ADDENDUM 1

PROJECT: DOOR BID

SHALER AREA SCHOOL DISTRICT

Base Bid A – Reserve Primary, 2107 Lonsdale Street, Pittsburgh, PA, 15212

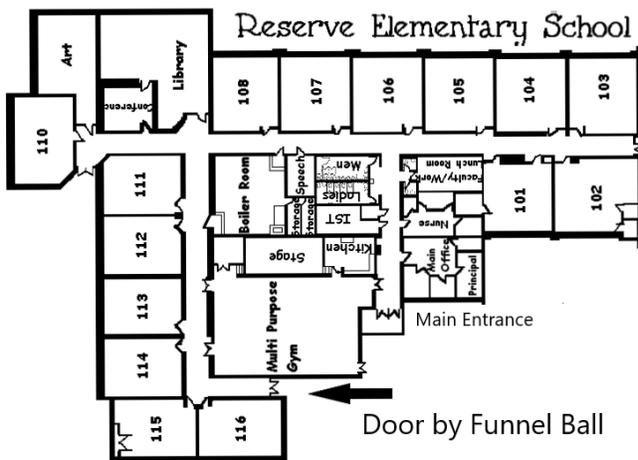
1. Replace page 6
Added: (1) Electric strike HES 9600
2. Replace page 7
Remove: Existing aluminum frame to remain
Added: (1) Pair of flushbolts, (1) Overlapping "T" Astragal

Exterior Entrance by Funnel Ball – Install a Special Lite Entrance System and Hardware– Aluminum closed tube frame clear anodized SL260 (2"x6") 92"x114" – (1 pair) FRP doors 72"x84", Model SL17 blue with 1/2 glass visions; (2) Continuous gear heavy duty hinges, SL11HD clear anodized; (1) Keyed electric removeable mullions, clean anodized SL60KE; (2) Rim exit device, 2103 x 630; (1) Rim cylinder housing to accept your Best 1C core 626 for the exterior of the active door. **(1) Electric strike HES 9600**
